NORTH CAROLINA DEPARTMENT OF TRANSPORTATION
FERRY DIVISION
139'-6" x 40' x 9"

MAIN DECK STRUCTURE MODIFICATIONS

DWG BY:	APPROVED BY:	SIZE	PROJECT NO.	DWG NO.	REV
BTJ	JJM	D	X	NC-140-03B	2
DATE: JAN. 26, 2023	DATE APPROVED:	SCALE: 3/16" = 1'-0"			SHEET: 1 OF 1

136'-6" x 40' x 9' CRANE BARGE

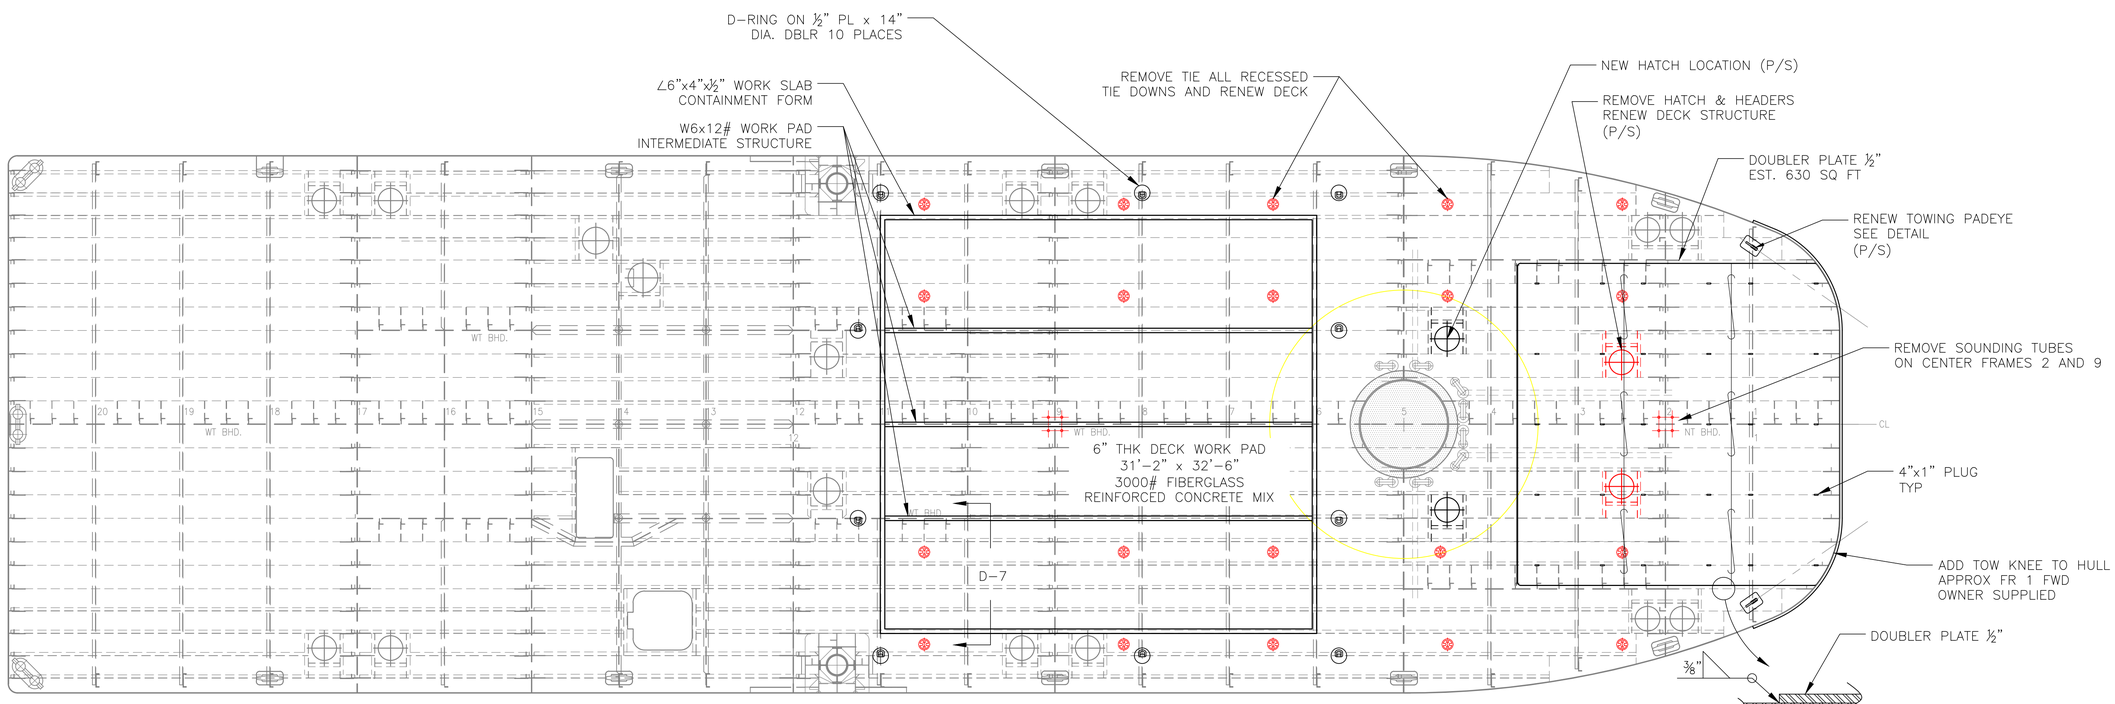
1. ALL ITEMS SHOWN IN RED TO BE REMOVED.
   - BOLT DOWN HATCHES, IWO DOUBLER, AND ASSOCIATED LADDER TO BE RELOCATED AFT.
2. DOUBLER PLATE, HALF INCH, TO BE ADDED TO BOW. PERIMETER AND JOINTS IN DOUBLER PLATE SHALL FULLY WELDED. PLUG WELDS ARE LONGITUDINAL AND ALINE WITH UNDERLYING DECK STRUCTURE.
3. ALL RECESSED TIE DOWNS TO BE REMOVED (20).
4. MAIN DECK, BETWEEN FRAMES 5 AND 14 TO BE EXAMINED AND REPLACED WHERE WASTED EXCEEDS 20%
5. ALL DECK PLATE PATCHES SHALL CROSS TWO STIFFENERS, PLUS 6" BEYOND, AND HAVE A MIN. WIDTH OF 18".

REV No.	DESCRIPTION	BY	DATE
1	ADDED PAD EYE DETAIL. REVISED CONCRETE PAD SIZE	BTJ	1/27/2023
2	REVISED D-RING LOCATIONS PER OPERATOR COMMENTS	BTJ	2/6/2023
